DESIGN <i>KE</i>	DRAWN BY <i>KE</i>	DART AEROSPACE LTD HAWKESBURY, ONTARIO, CANADA	
CHECKED <i>KE</i>	APPROVED <i>KE</i>	DRAWING NO. DSI 9128	REV. A SHEET 1 OF 2
DATE 98.12.15		TITLE CHANGE HINGE	SCALE NTS
A	98.12.15	NEW ISSUE

DART SERVICE INSTRUCTION

AMEND INSTALLATION DRAWING D350-600 REV. B

STA: SH93-88
STC: SR00098NY

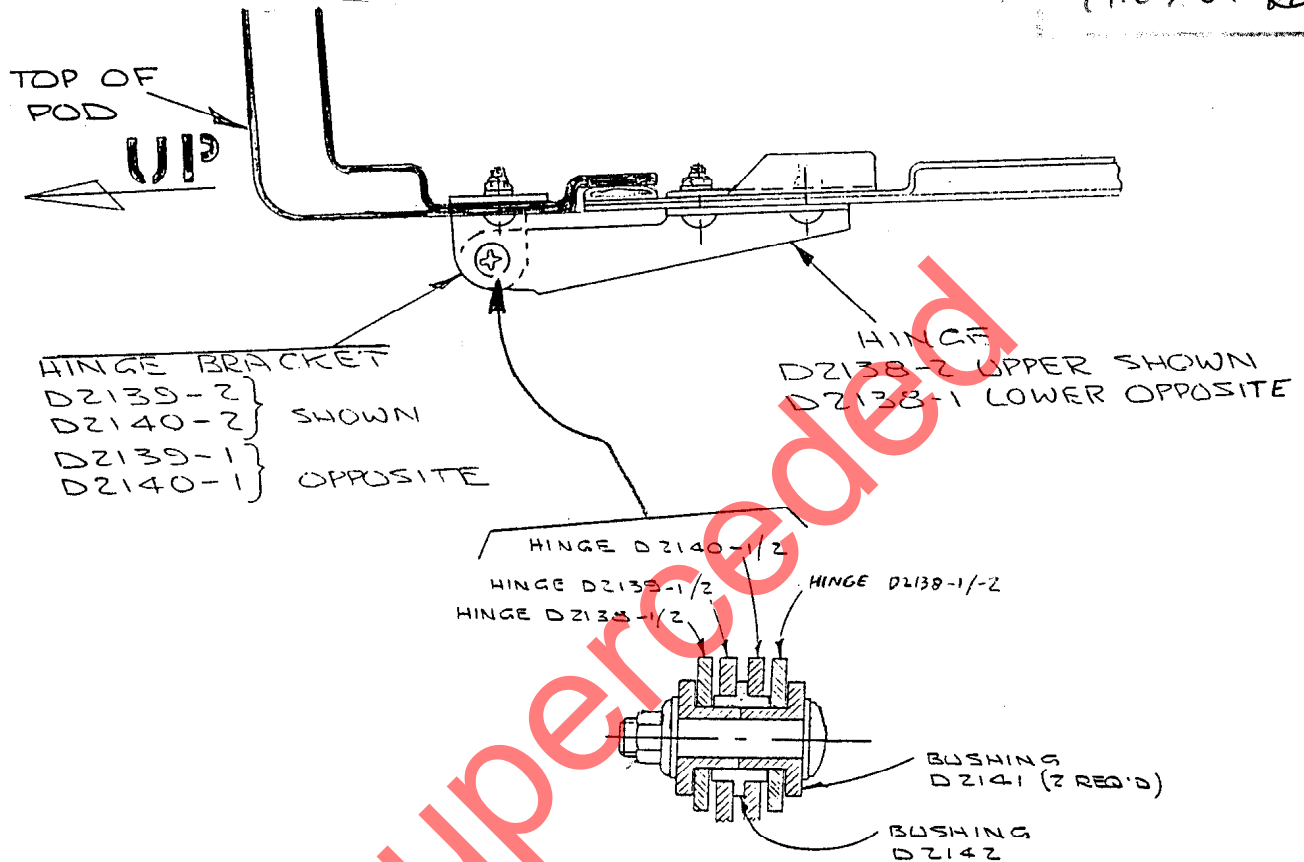
- (2) REMOVE THE FOLLOWING HINGE PARTS FROM D350-600 REV B:

- (3) REPLACE WITH THE FOLLOWING PARTS:
